PROJECT: THE HAGEDORN AVIATION COMPLEX

ADDENDUM NUMBER 3 DATED 14 January 2010

This addendum is part of the Contract Documents and modifies the Project Plans and Specifications as follows:

1 ELEVATION - ARCH. ALUMINUM FENCE *SC: 1/2" = 1'-0"*
A1.5

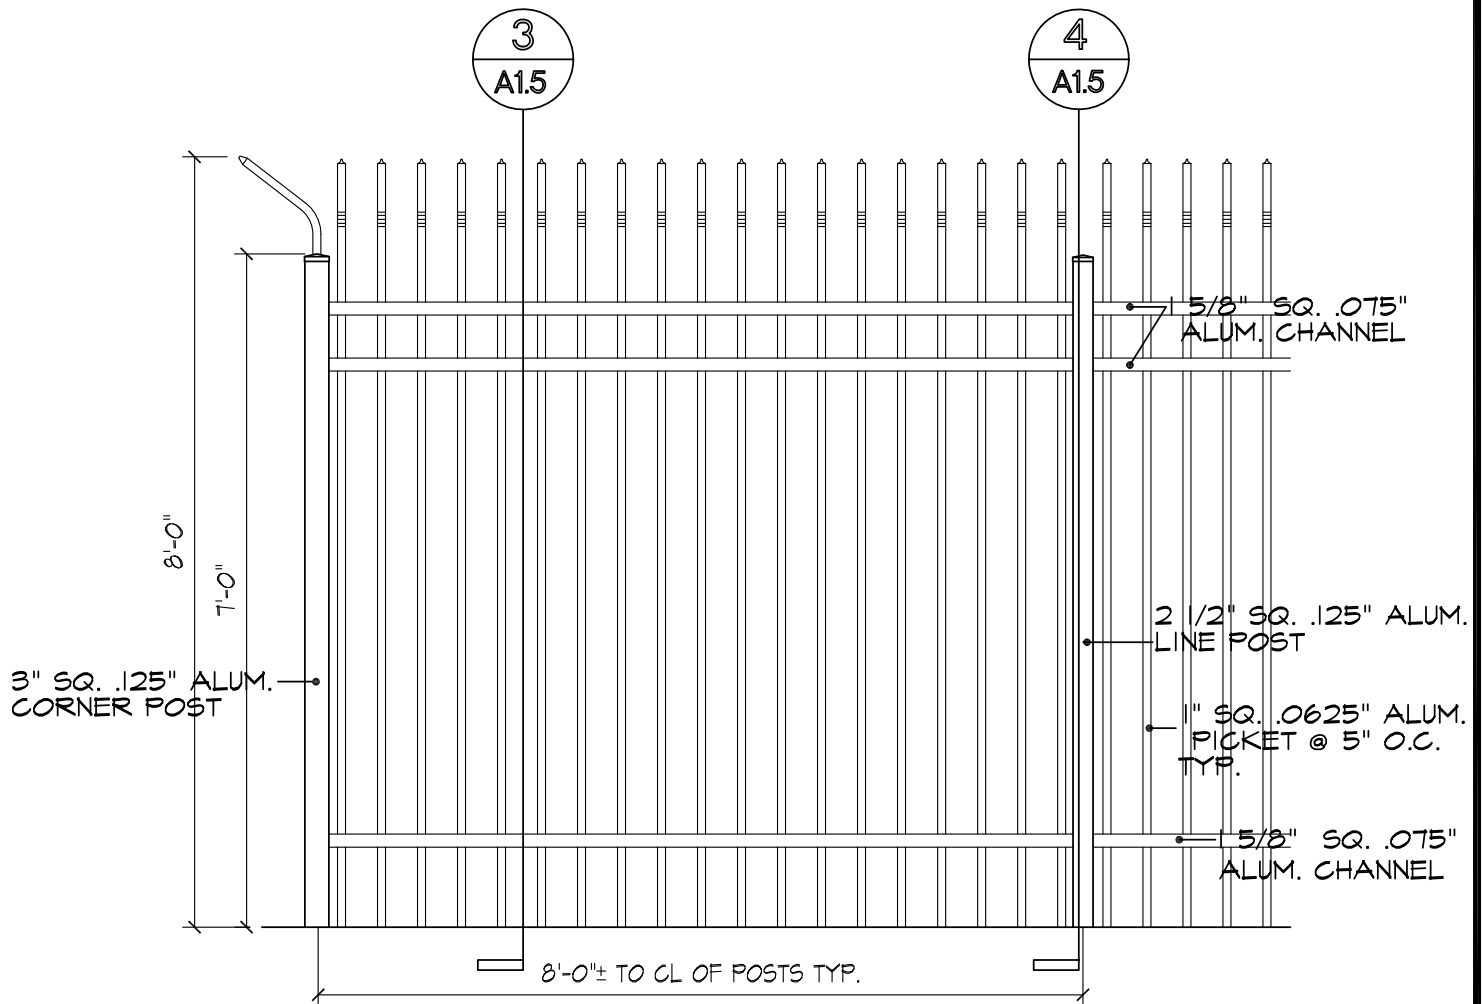
- AMS Laboratory Building: 209, 210, 211, 212, 213, 214, 215, 216, 217, 219
- Flight Maintenance Hangar: 110, 111, 112, 114
- A3.11 DRAWINGS: SHEET A1.5
Refer to attached sketches SK-A1.5-1 & SK-A1.5-2 for additional information regarding the architectural aluminum fencing.

1. FENCE SYSTEM TO BE EQUAL TO IDEAL ALUMINUM PRODUCTS (386)736-1700
2. SYSTEM TO BE FULLY WELDED
3. PROVIDE POWDER COAT FINISH W/ LIFETIME WARRANTY.

8
A1.6

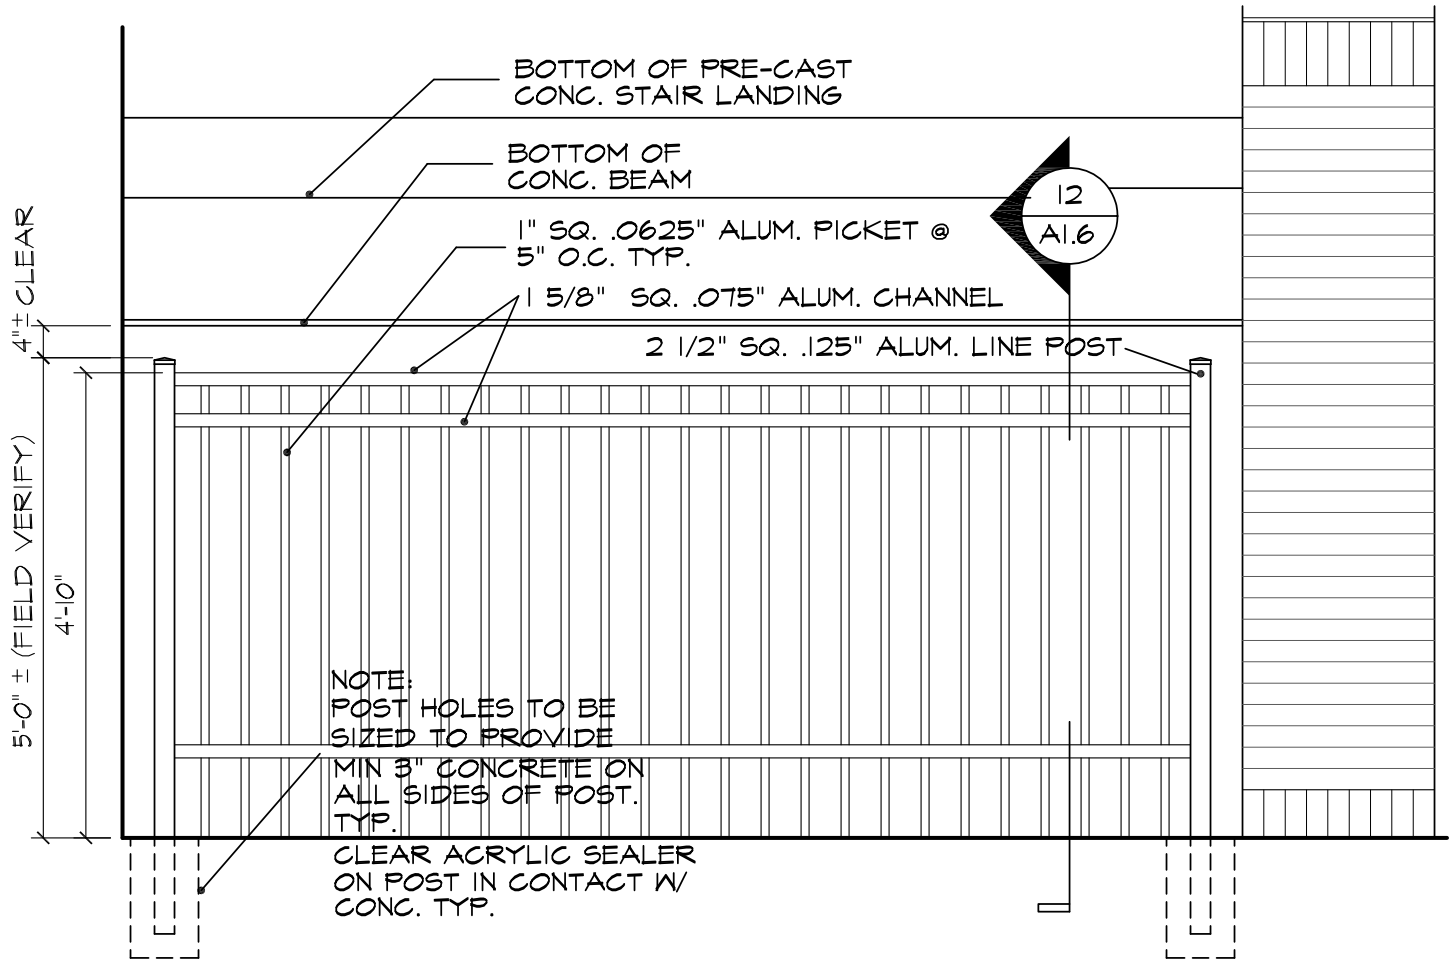
Refer to attached sketches SK-A1.6-1, SK-A1.6-2, SK-A1.6-3 & SK-A1.6-4 for additional information and miscellaneous revisions to the architectural aluminum fencing and security gate.

3 SECTION
A9.3 AT TAMBOUR DOOR

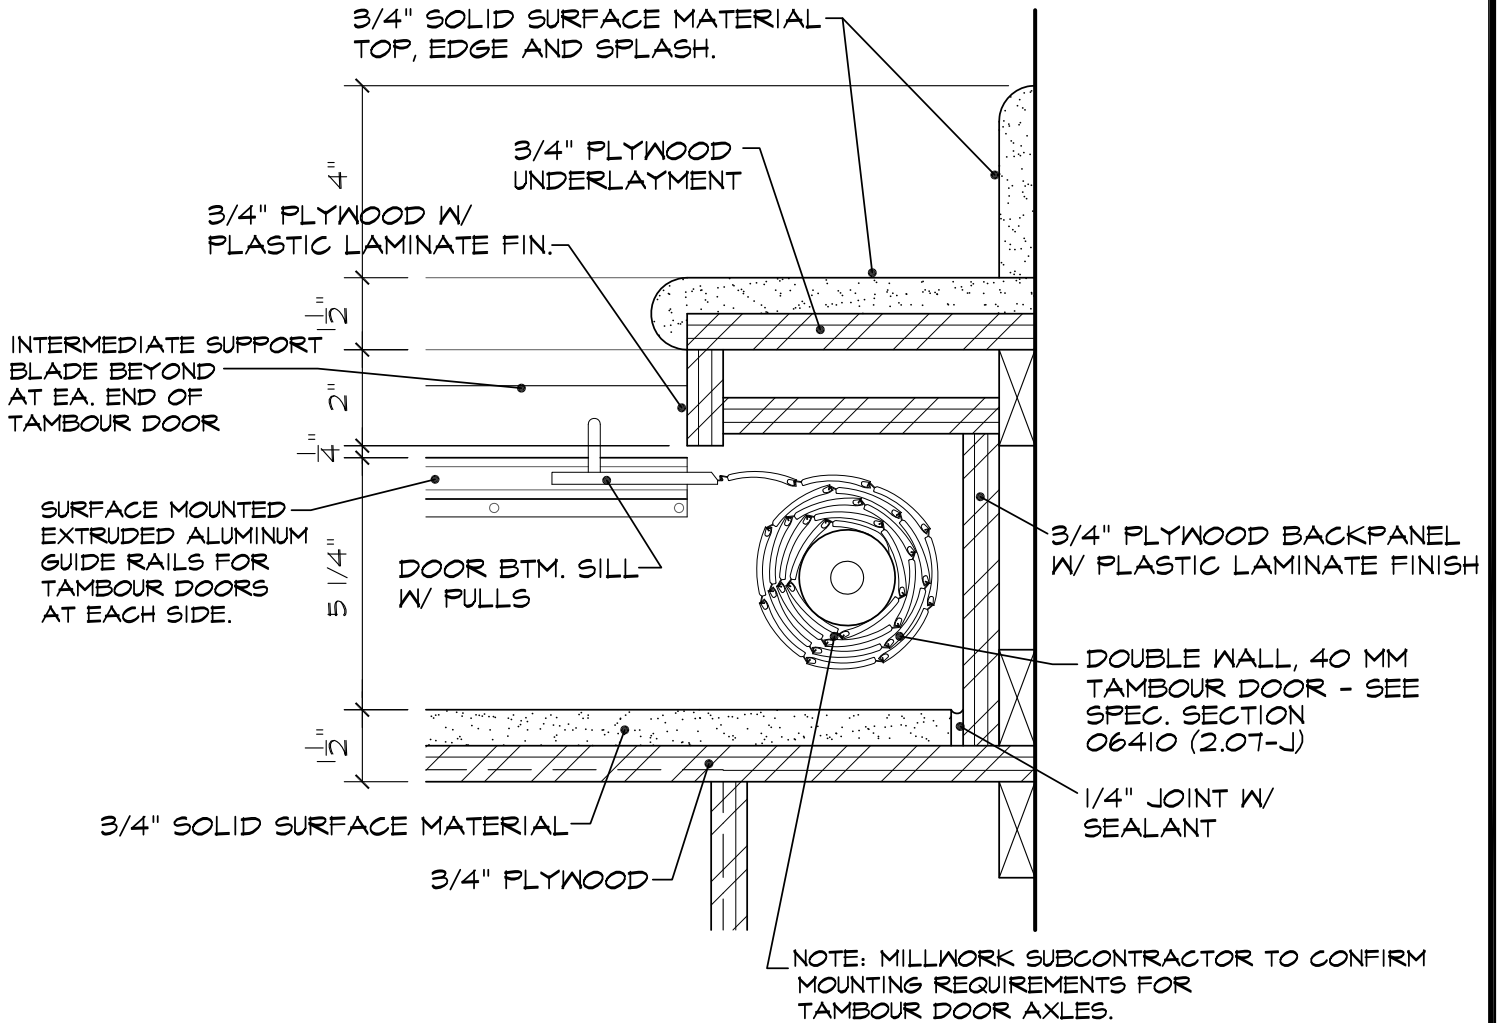
Refer to attached sketches SK-A9.3-1, SK-A9.3-2, & SK-A9.3-3 for miscellaneous revisions related to the tambour door at the clip board storage cabinet.
